Subject: MHI's Amended Response to US-APWR DCD RAI No. 695-4934 Revision 2 (SRP 06.03)

Amended Response to Request for Additional Information
No. 695-4934 Revision 2 (SRP 06.03)

RAI NO.: NO. 695-4934 REVISION 2
SRP SECTION: 06.03 – EMERGENCY CORE COOLING SYSTEM
APPLICATION SECTION: 6.3
DATE OF RAI ISSUE: 2/18/2011

QUESTION NO.: 06.03-88

RAI Figure 6.3.88-1 NaTB Solution Transfer Piping Diagram

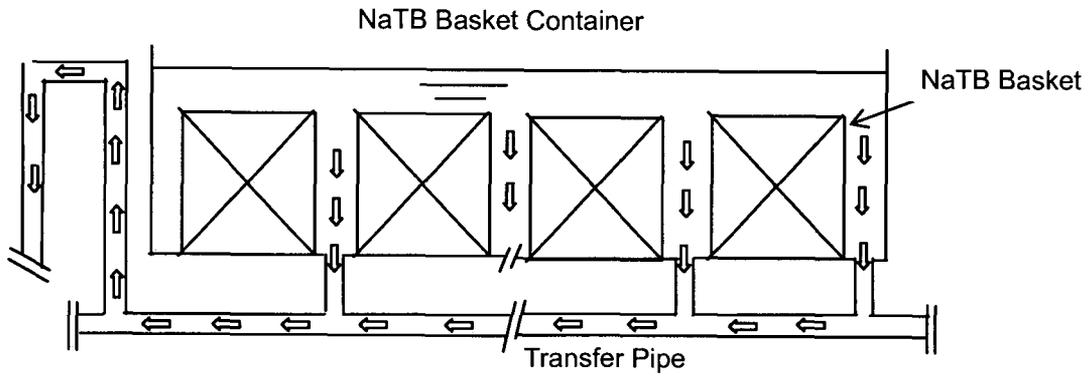
- 1) Please provide a detailed description including elevations of this flow path and where it combines with the flow path from the other basket container (See DCD Figure 6.3-12). Provide a comparison of driving head and piping pressure loss and any relevant assumptions.

- a.1) RAI Figure 6.3.88-1 shows the flow paths from the NaTB basket containers A, B, and C to the RWSP with elevations. RAI Figure 6.3.88-1 also shows the flow rate of each path that is used to evaluate piping pressure loss. Please refer to the response to Item (c) below for the comparison of driving head and piping pressure loss, and the relevant assumptions.

RAI Figure 6.3.88-2 NaTB Solution Flow Path

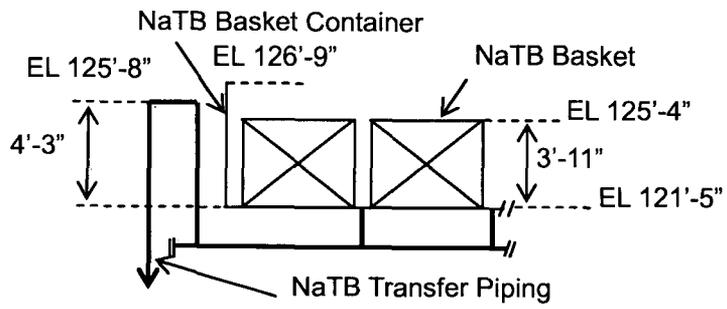
- 2) Since the piping inlet for fluid removal from the basket container appears close to the bottom of the basket container, justify that debris cannot accumulate in the lower part of the basket container and block the flow to the RWSP.

- a.2) The piping inlets are provided between the NaTB baskets in the container as shown in RAI Figure 6.3.88-2. There are no obstacles above the piping inlet at the bottom of container. Therefore, debris flows into the pipe inlet with the NaTB solution and is discharged into the RWSP without blocking the connection to the transfer pipe.

RAI Figure 6.3.88-3 Elevations around NaTB Basket

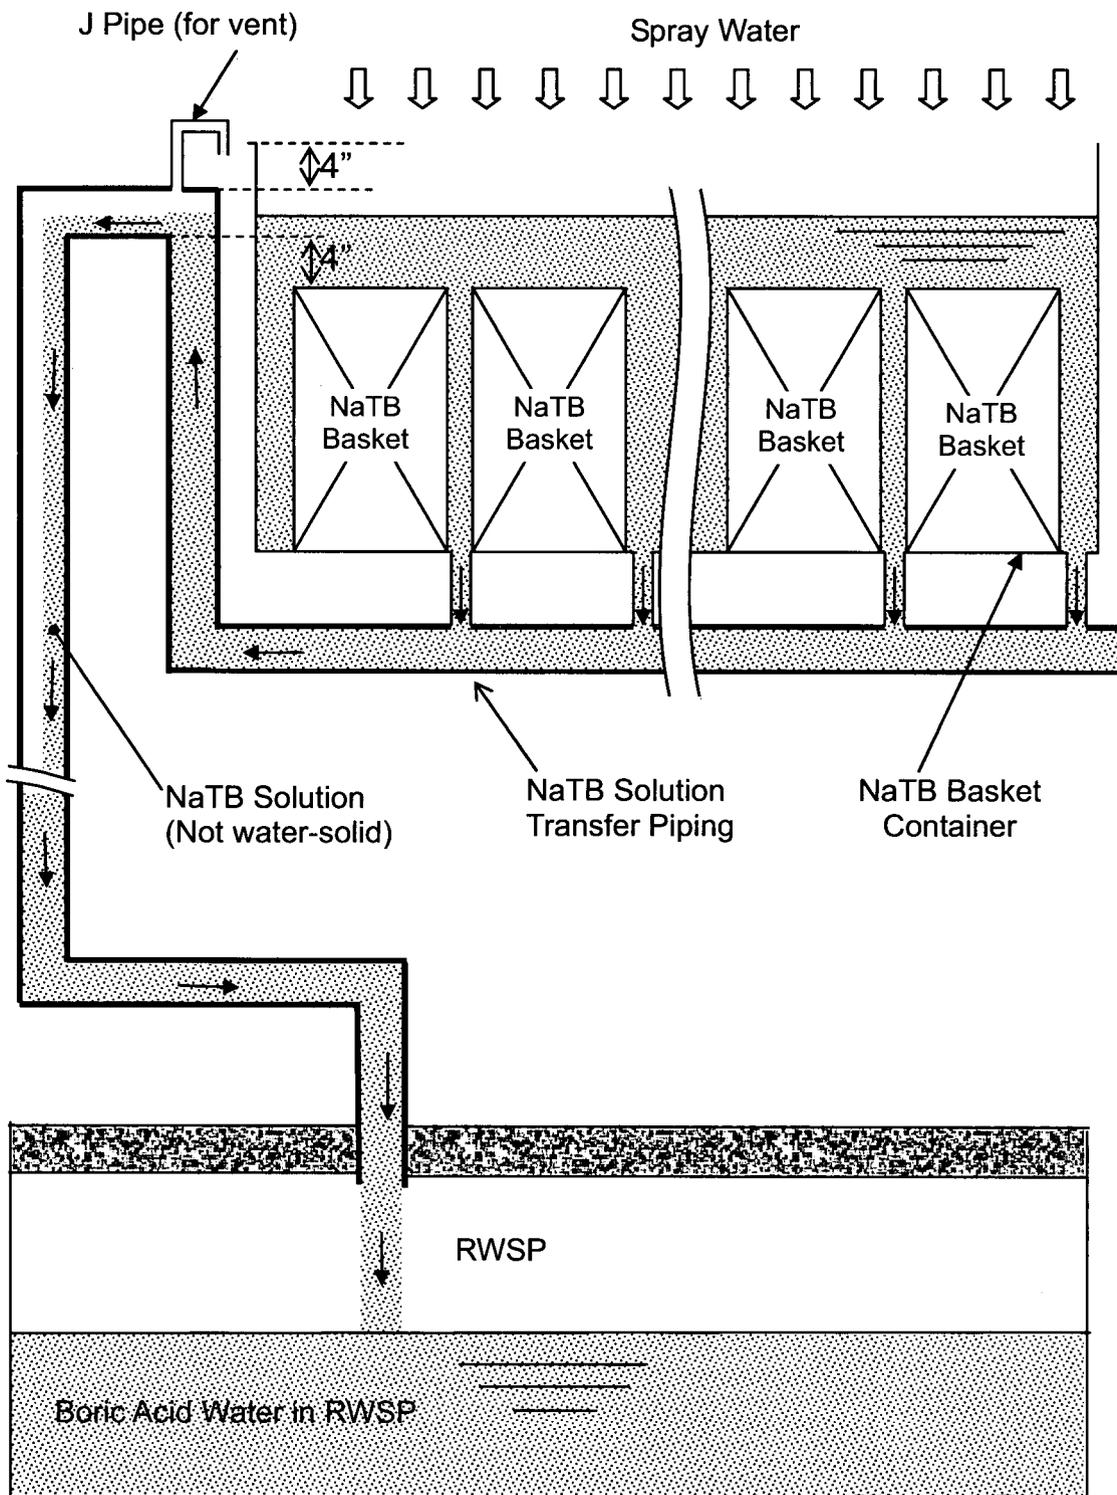
- d. In Figure 6.3-12 Note 2 states "Raise the outlet piping to a level 4'-3" higher than the bottom of the NaTB basket container and layout piping with a down slope from the outlet piping to RWSP." Figure 6.3-11 indicates that the height of the NaTB basket is 4'-11". How do you know that you are getting enough water coverage on the NaTB baskets to satisfy the design basis of maintaining the correct pH of the RWSP? Provide a calculation or discussion that supports the claim that the NaTB baskets would be fully immersed during minimum flow conditions for the containment spray ring D.
-

- d. The height of NaTB basket is 3' -11", as shown in RAI Figure 6.3.88-3, not 4' -11" as shown in DCD Figure 6.3-11. DCD Figure 6.3-11 will be revised to include the correct value as shown below.

As shown in RAI Figure 6.3.88-4, the transfer piping exits from the bottom of the container and rises to the horizontal portion of the U-pipe. The bottom of the U-pipe is located [] inches higher than the top of the basket, the U-pipe is 8.625 inches in diameter, and the top of the U-pipe is approximately 4 inches below the top of the basket container. As shown in RAI Figure 6.3.88-4, the spray water flowing into the container need to overflow

the bottom of the U-pipe to be transferred to the RWSP. Therefore, the water level in the container is maintained at a level 4 inches higher than the top of the basket even though the minimum flow conditions for the containment spray ring D, and the baskets are completely submerged in the spray water.
